## MEMORANDUM

**To:** The Design Advisory Board  
**From:** Mary O'Neil, AICP, Principal Planner  
**RE:** ZP21-0358CA/CU; 40 Kingsland Terrace  
**Date:** October 27, 2020

**File:** ZP21-0358CA/CU  
**Location:** 40 Kingsland Terrace  
**Zone:** RL **Ward:** 6S  
**Parking District:** Neighborhood  
**Date application accepted:** October 1, 2020  
**Applicant/ Owner:** Katie Menson, Kellen Brumsted  
**Request:** Demolish existing garage; construct new garage with 616 sf. Accessory Dwelling Unit (ADU.)

Principal structure, 40 Kingsland Terrace

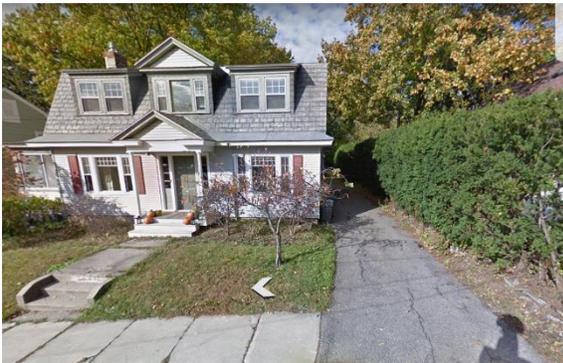
There is no visibility (from Google images) of this replacement structure from the public right-of-way. (See image, left.)
